State of New Mexico
 Energy, Minerals and Natural Resources

SUNDRY NOTICES AND REPORTS ON WELLS
 (DO NOT USE THIS FORM FOR PROPOSALS TO DRILL OR TO DEEPEN OR PLUG BACK TO A DIFFERENT RESERVOIR. USE "APPLICATION FOR PERMIT" (FORM C-101) FOR SUCH PROPOSALS.)

Mesquite SWD, Inc. requests permission to run a tapered tubing string in this well. We propose To run 7" tubing inside the surface and intermediate hole and 5 1/2" tubing inside the liner.

Mesquite SWD, Inc.
VL SWD #1
 API #30-015-44602
 2142' FSL & 249' FEL
 Section 14, T24S, R28E, Eddy County, NM

Proposed Well Bore Diagram

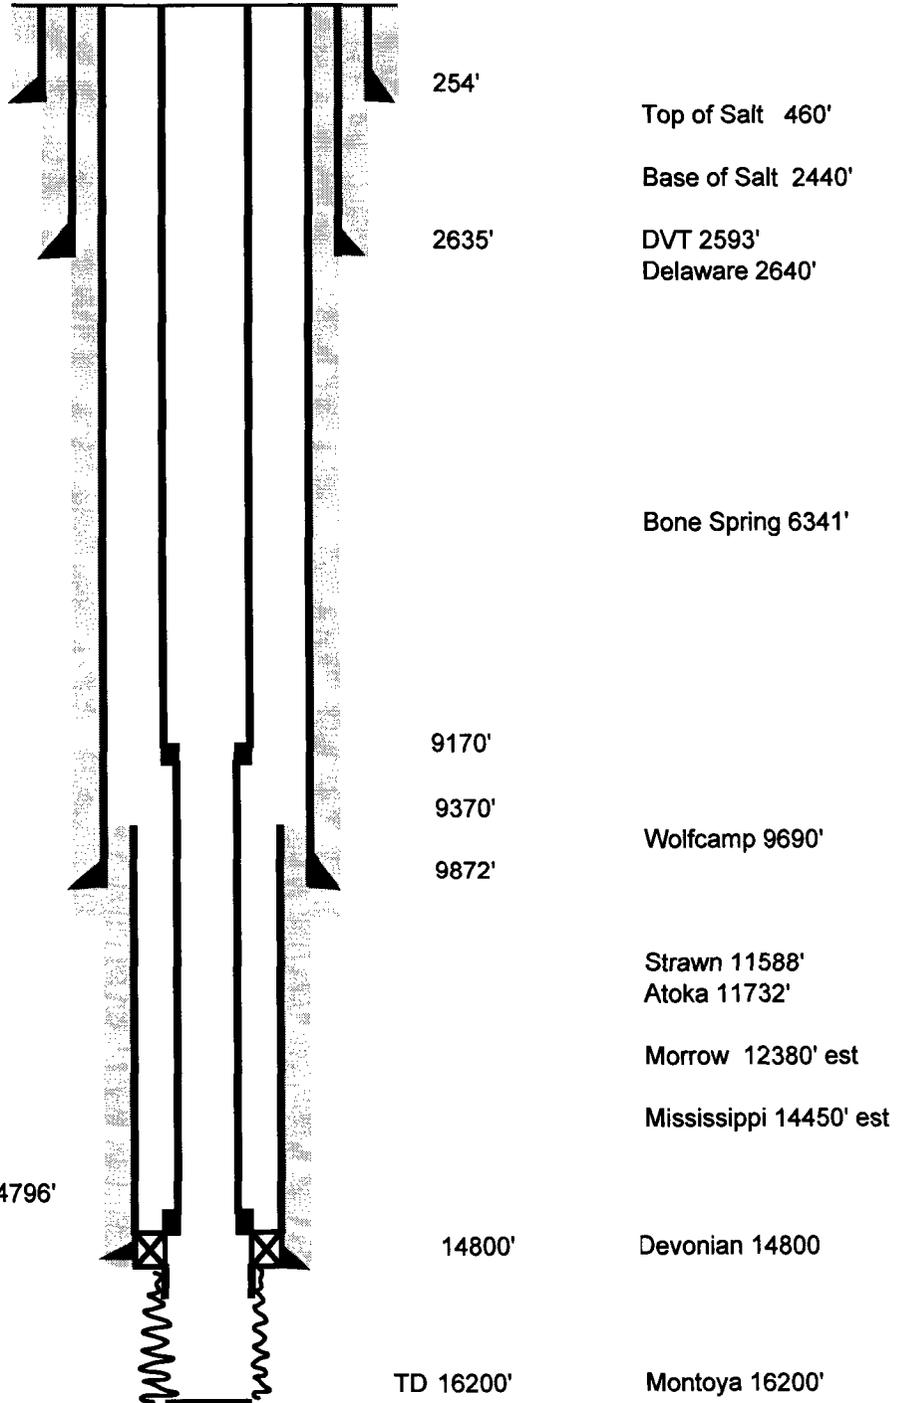
7" 26# P-110 Tbg @ 9169'
 7" x 5 1/2" X-Over @ 9170'
 5 1/2" 20# JFE Bear Tbg @ 14795'
 7 5/8" x 5 1/2" Dual Bore Permapak Packer @ 14796'

APPROVED BY: Raymond H. Redany TITLE Geologist DATE 2-7-18
 Conditions of Approval (if any):
